**SECTION 00 91 13.01**  
**ADDENDA #01**

- A. Project Name: Royal C. Johnson Veterans Memorial Medical Center New Front Lobby & Primary Care Addition.
- B. Owner: U.S. Department of Veterans Affairs.
- C. Owner Project Number: 438-480
- D. Architect: Stone Group Architects.
- E. Architect Project Number: 201909.
- F. Date of Addendum: February 13, 2024.

1 GROUND LEVEL HVAC PLAN - AREA A  
1/8" = 1'-0"

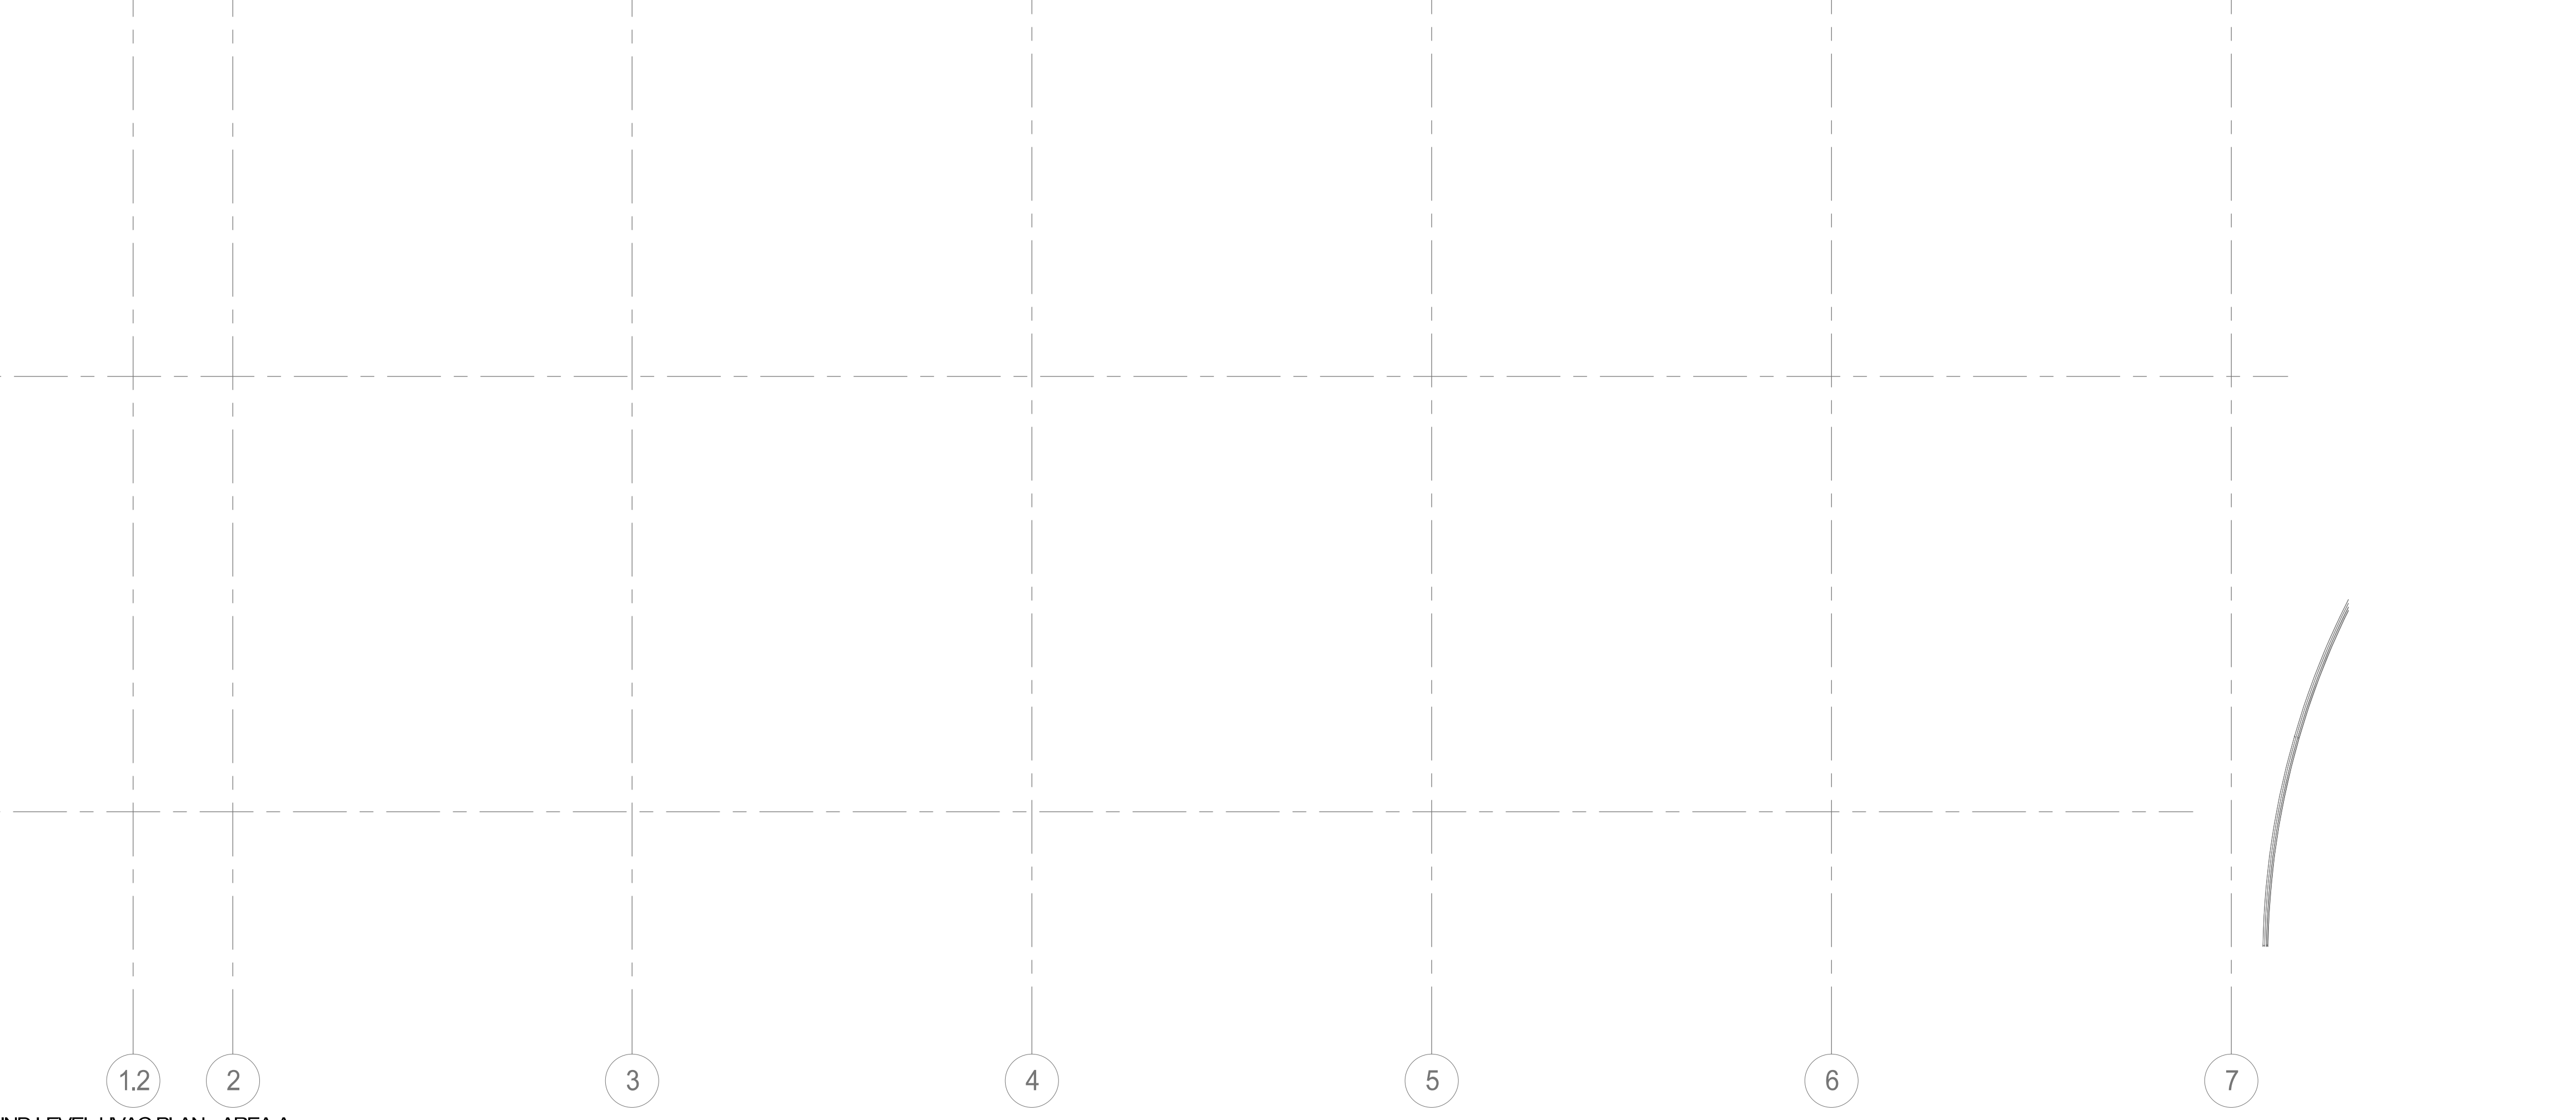
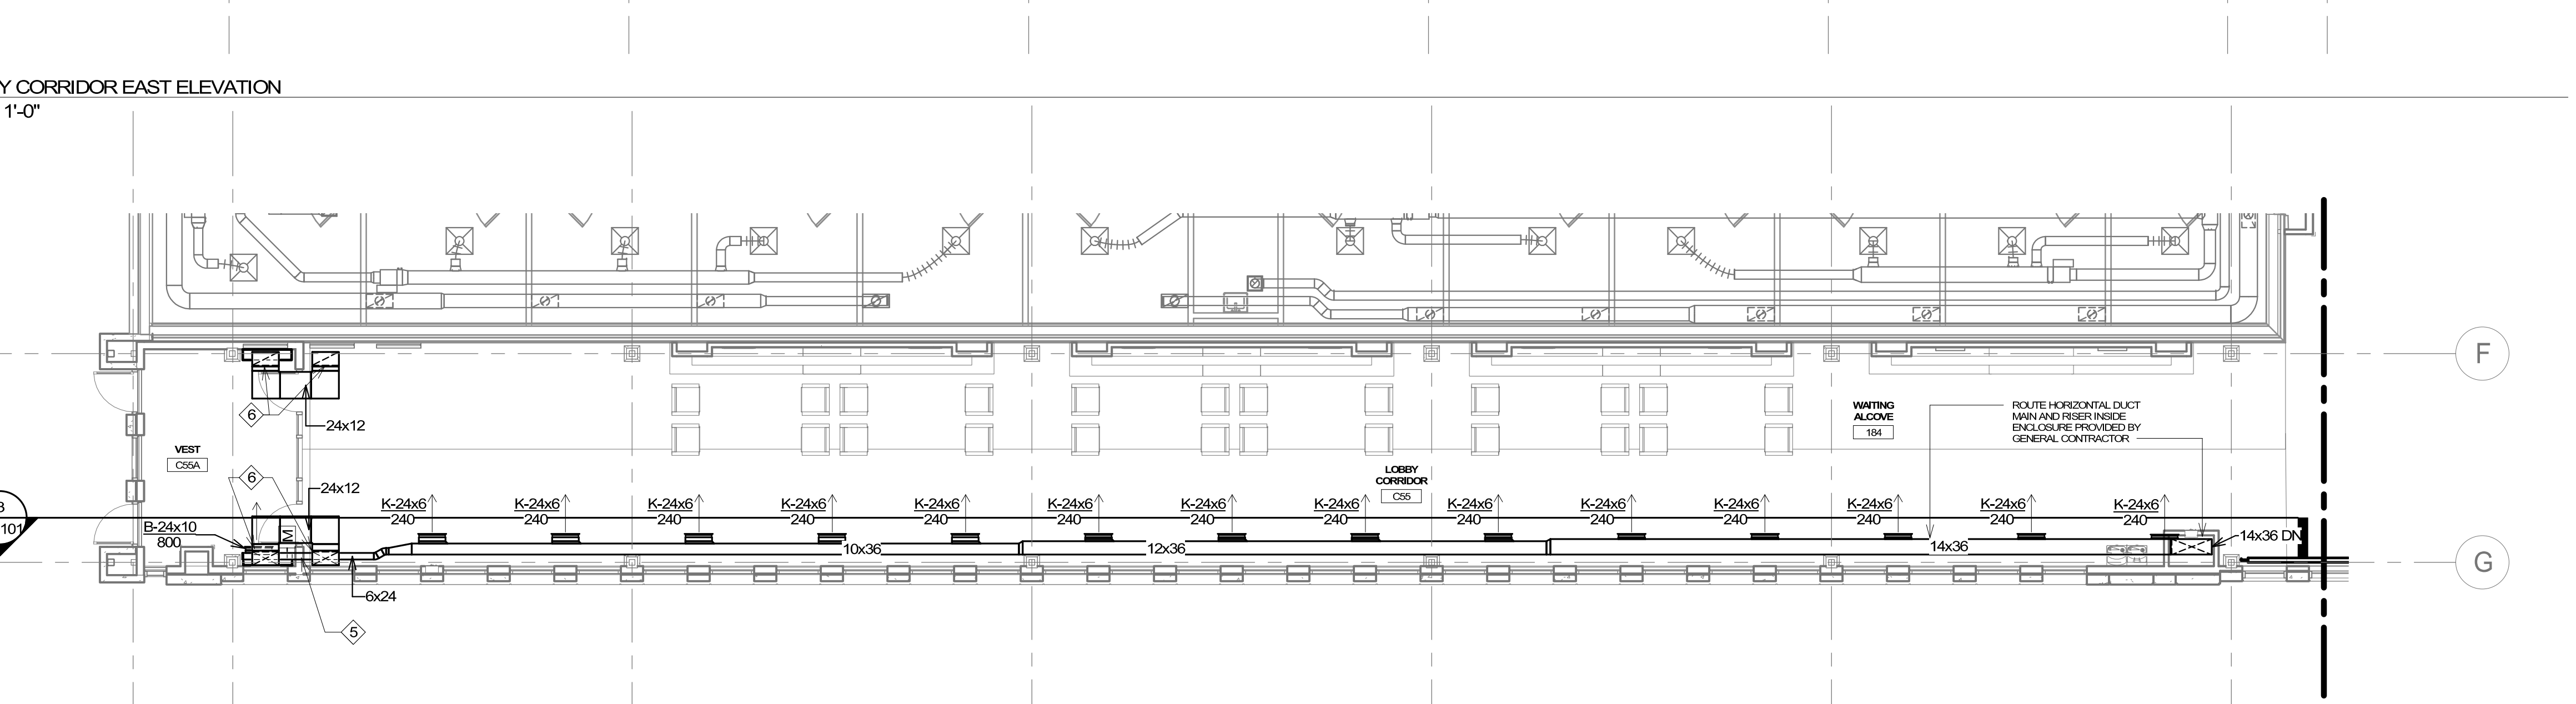
1. Clarification of SPG bus bar locations added to frames W16 and W17.
- U. Sheet MH101 - GROUND LEVEL HVAC PLAN - AREA A (reissued).
1. Clarified that bus stop equipment will be deleted under acceptance of deduct alternate #7.

Drawing Number  
EE100

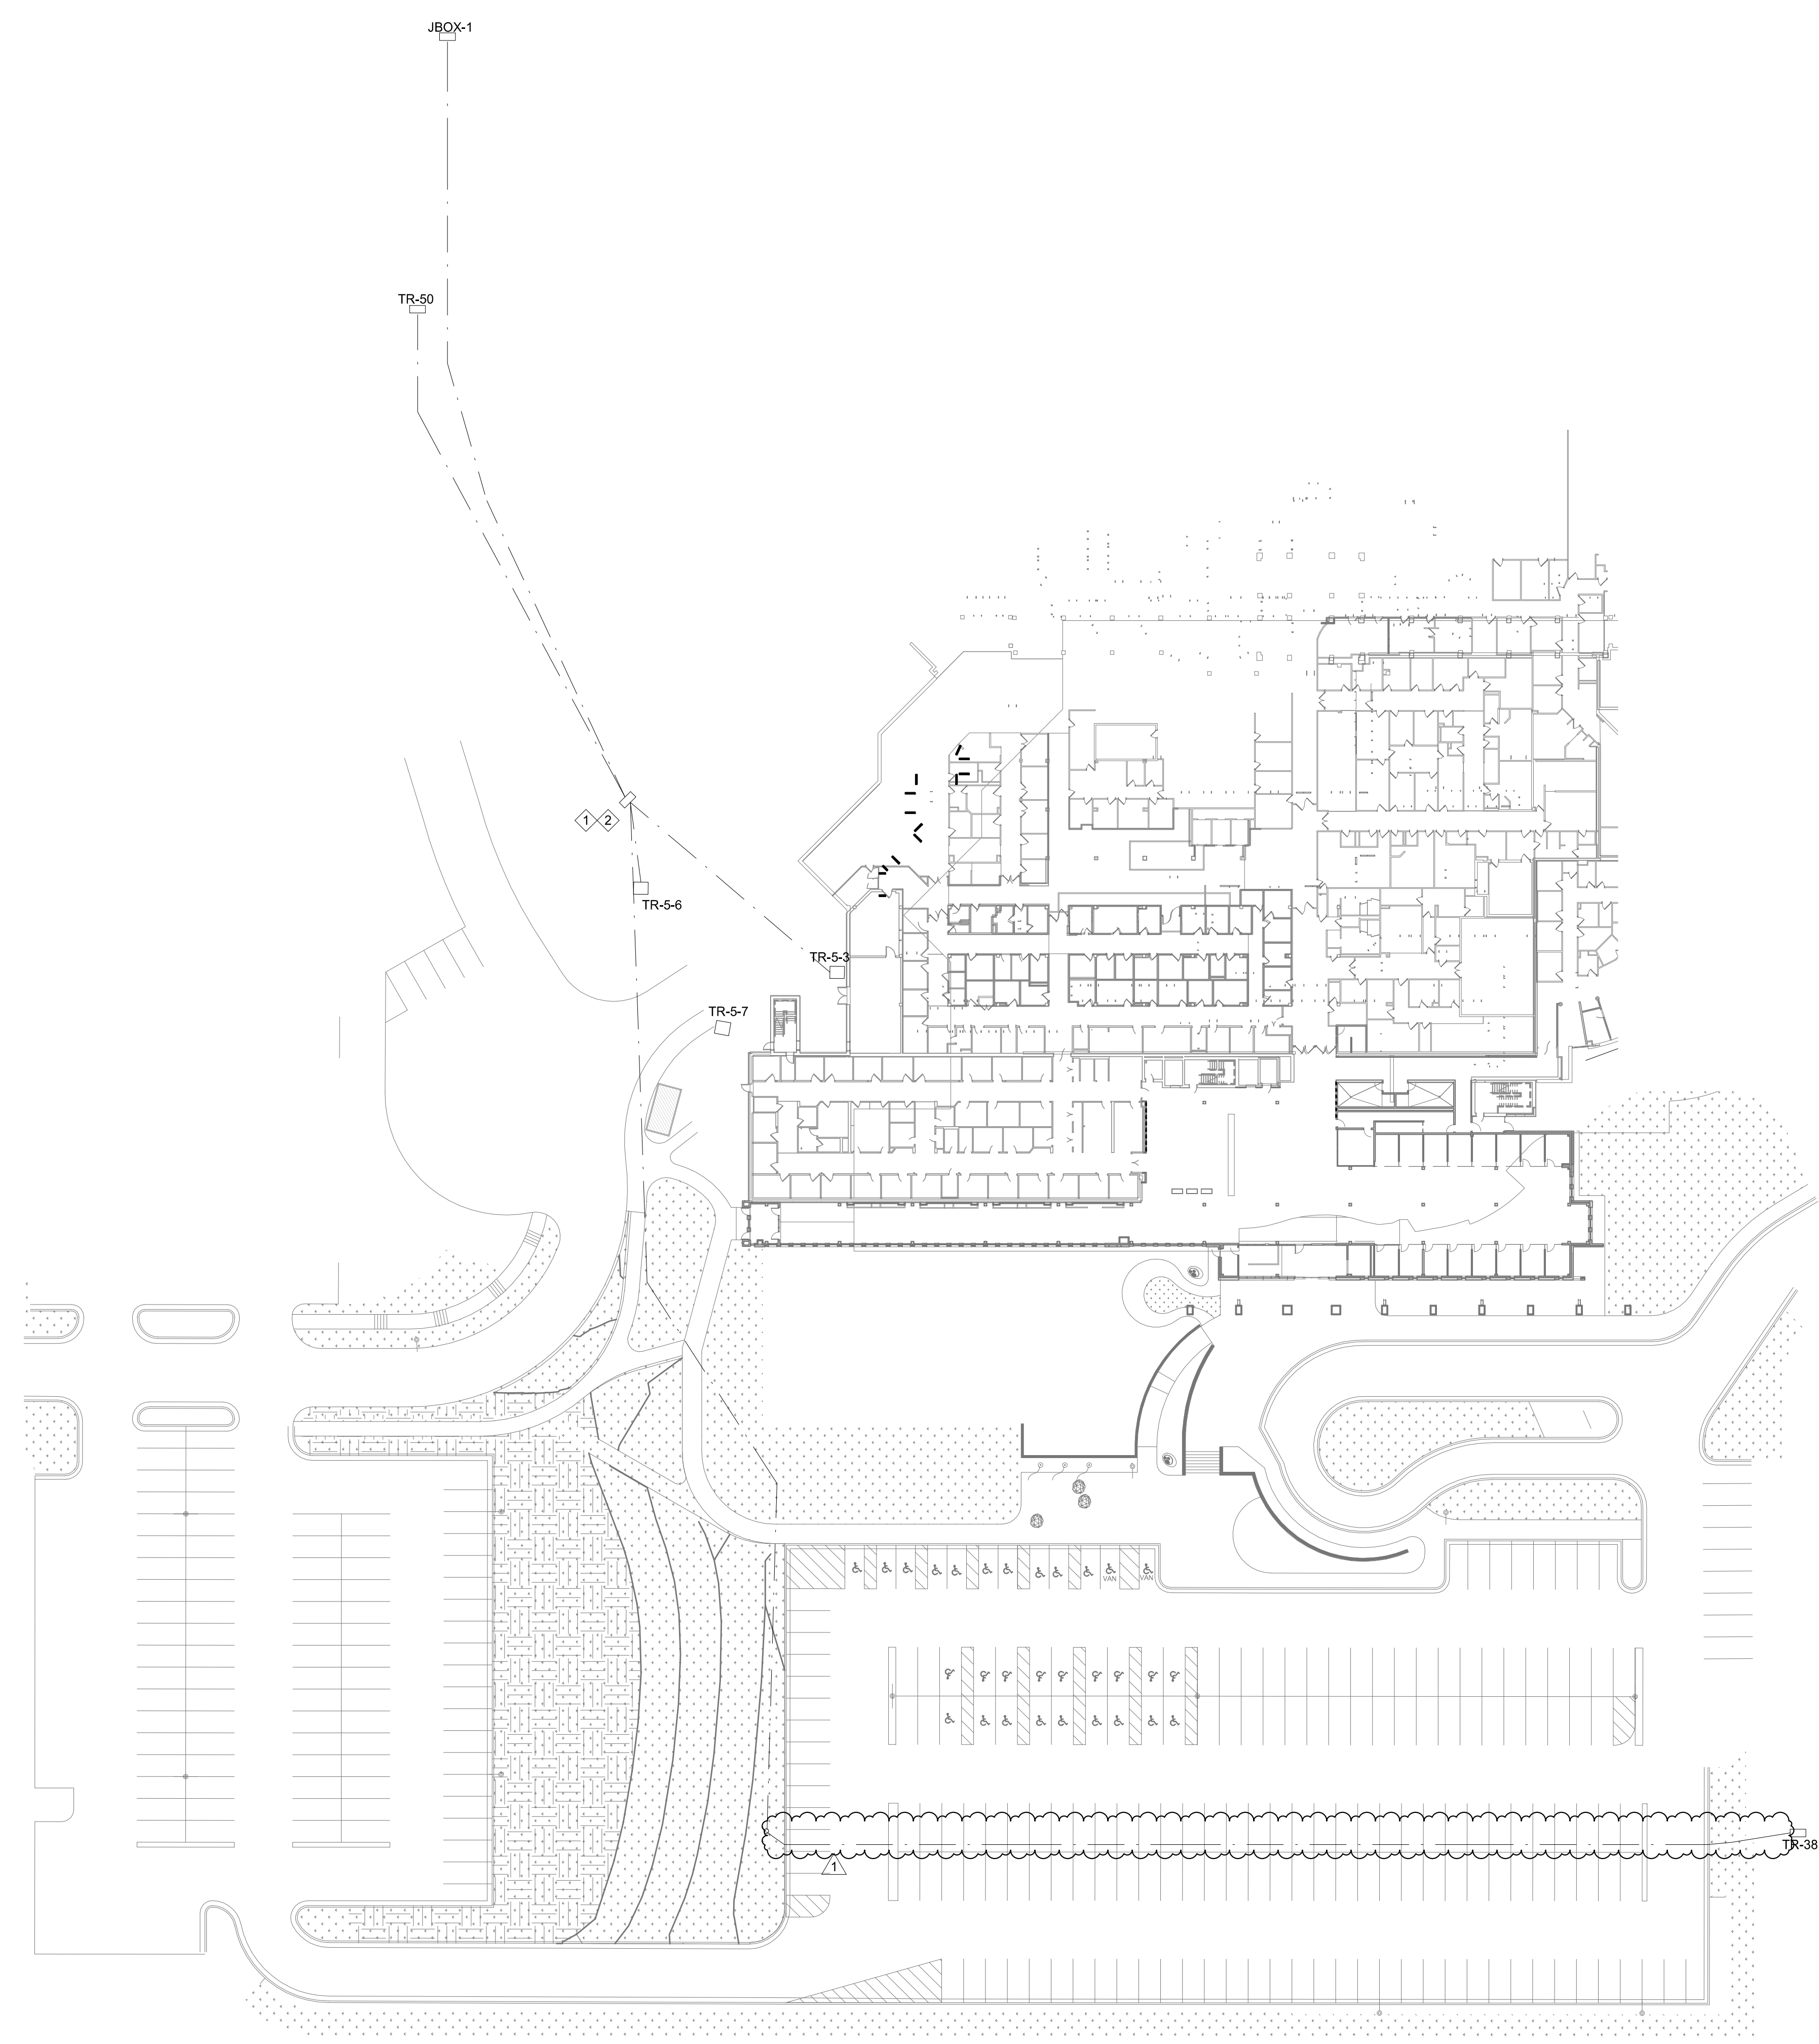
- Z. Sheet EE100 - ELECTRICAL SITE PLAN (reissued).
1. Update keynote number to correct keynote.
  2. Revise keynote 3.
  3. Add keynote 9 Deduct 7 clarity
